**HISTORIC LANDMARK COMMISSION**  
**CERTIFICATE OF APPROPRIATENESS – REVISED STAFF REPORT**  
**MAY 24, 2021**  
**HR-2021-063830**  
**1113 E. 9<sup>TH</sup> STREET**  
**ROBERTSON/STUART & MAIR HISTORIC DISTRICT**

Construct a 1-story side addition to a contributing building.

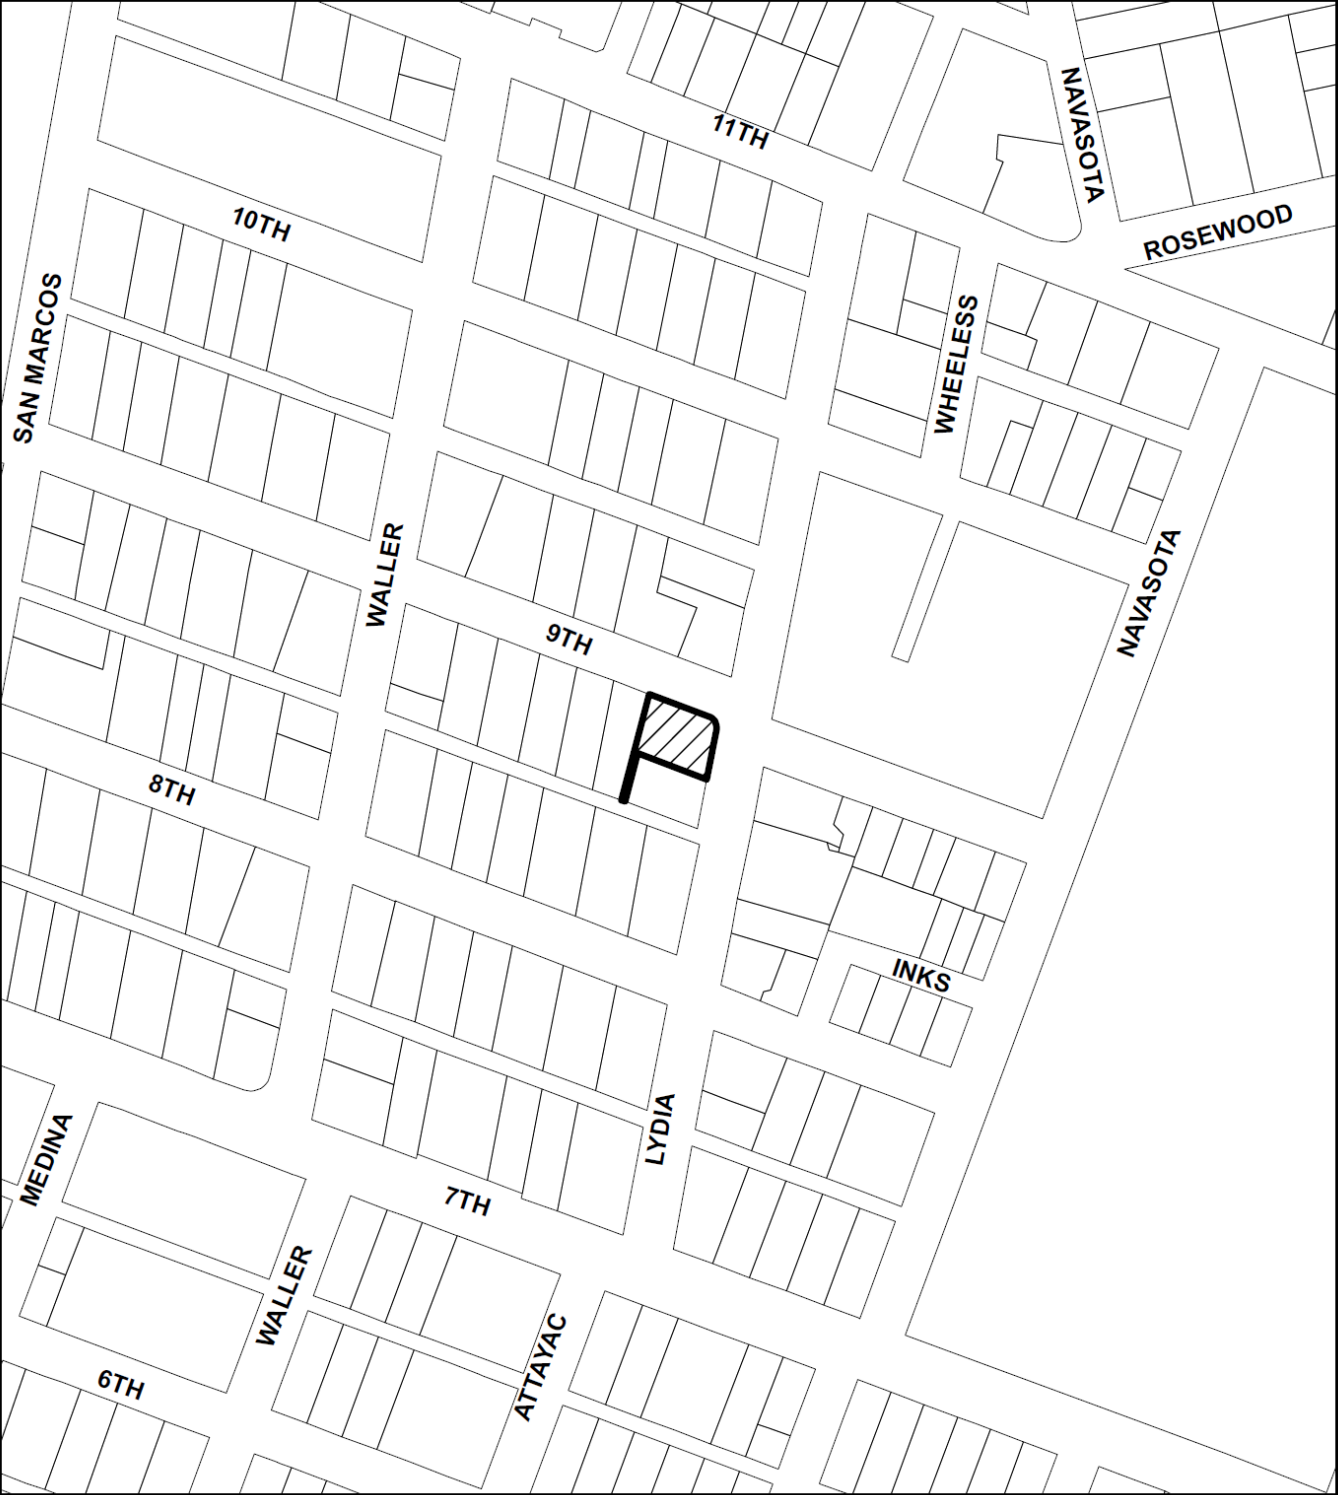
Recommend horizontal cladding and single window on front elevation; alter addition roofline to give side gable more visual room. The recommended changes have been made.
